Planning Commission Staff Report

December 12, 2012
Item 6.b.

SUBJECT: P12-0556, P12-0557, and P12-1790

PURPOSE: Applications for: 1) Conditional Use Permit and Design Review approvals to demolish the existing 76 Conoco Phillips service station sales and restroom building, modify the location of fuel dispensers, construct an approximately 2,250-square-foot, 24-hour 7-Eleven convenience market, and install related improvements; and 2) a Variance from the Municipal Code to locate parking spaces within setback areas.

FIGURE 3: Site Plan

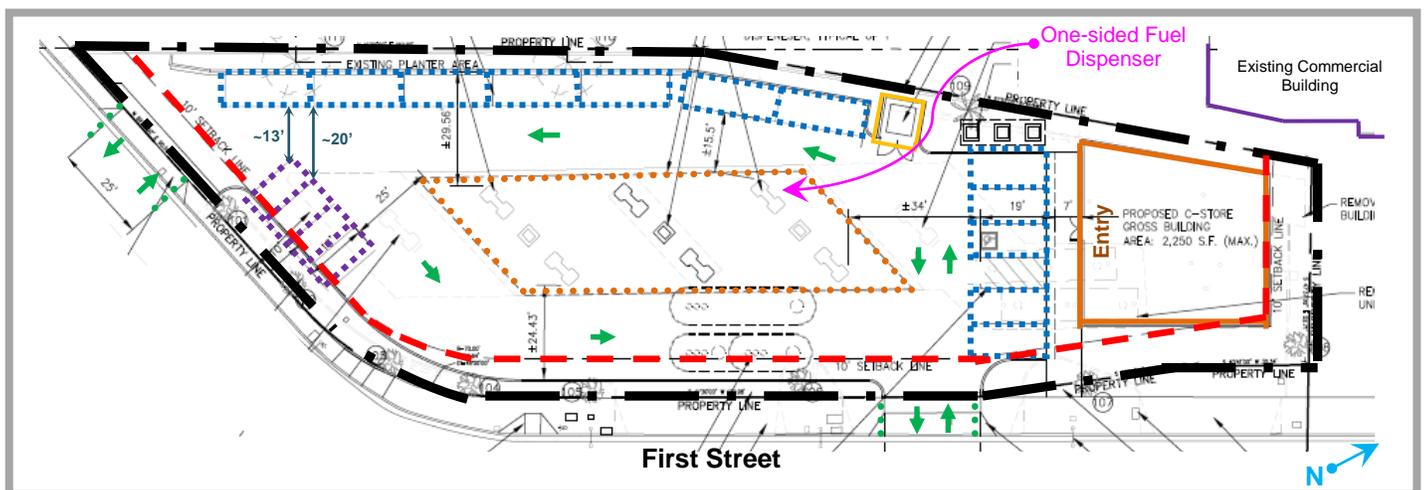
However, staff, including the City Traffic Engineer, has concerns regarding the compact parking space closest to the driveway from Ray Street. This space in its current location blocks incoming traffic since the total aisle dimension is only 13-feet between the parking spaces, and two-way travel requires a minimum of 20-feet. The applicant is willing to move this space to the other end of the parking spaces, which would result in a distance of approximately 20-feet between the end of the western-most compact space and the parallel parking space along the western property line. However, moving this parking space would require a Variance to locate it in the setback area. A Variance would also be required since all four compact spaces have a 2-foot overhang into the front yard setback area along Ray Street, and the eastern-most standard space in front of the convenience market encroaches into the setback area along First Street. As discussed in this staff report, findings for the Variance cannot be made.

Even if this space were to be moved, staff believes the parking spaces adjacent to Ray Street would be underutilized due to the fact that they are on the other side of the site from the convenience market. Additionally, staff believes the parallel parking spaces located along the western property line would underutilized since they are difficult to maneuver into and out of. Thus, many people will likely park in the area along First Street instead of these designated parking stalls. Additionally, vehicles pulling into or leaving the spaces in front of the convenience market will conflict with the vehicular traffic coming in and leaving the driveway off of First Street.

In order to improve the on-site circulation, the applicant is willing to make the fuel dispenser that is furthest northwest one-sided (labeled as “one-sided fuel dispenser” in Figure 3) so that a vehicle parked in the parallel parking space closest to the trash enclosure can maneuver out of the space. Modifying this fuel pump allows the drive-aisle adjacent to this space to be 15-feet-6-inches wide to allow one-way traffic to travel between the areas in front of the convenience market and the driveway leading to Ray Street. However, a customer may still park his/her vehicle at the one-sided fuel pump if all of the spaces directly in front of the convenience market are taken, resulting in this drive aisle being partially or completely blocked. Furthermore, even with markings on the pavement, drivers may not comply with the one-way circulation system, creating the potential for additional circulation conflicts.

The proposed site plan would meet the minimum number of required parking spaces, but results in poor circulation and locating parking spaces within setback areas and far from the use they serve. For these reasons, staff does not support the parking and circulation.

FIGURE 5: Elevations for Convenience Market and Service Station Canopy

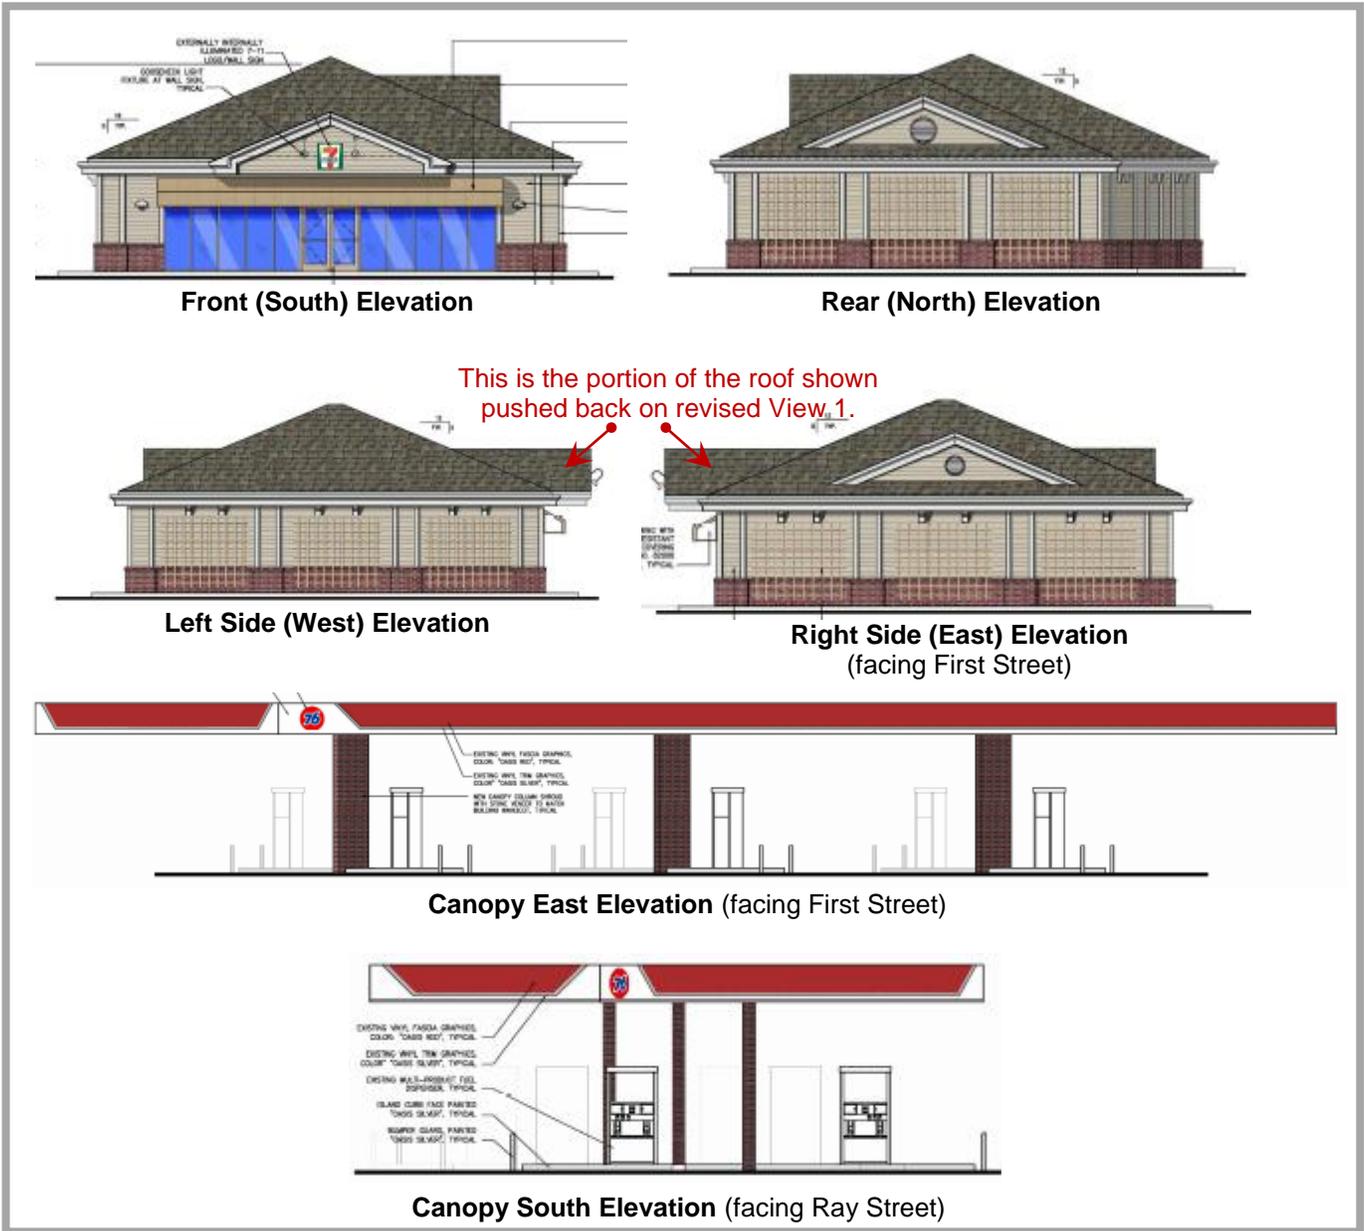
drawings do not show the canopy's gable ends with a low-pitched standing-seam metal roof, and incorrectly show the "76" logo sign on the First Street side when it is located on the Ray Street side of the canopy.

Although the convenience market will have a landscaped area meeting the above requirements, and an appropriately designed roof, the building lacks windows on the street side, and does not include architectural detail or accents at the pedestrian level, and does not screen parking from view.
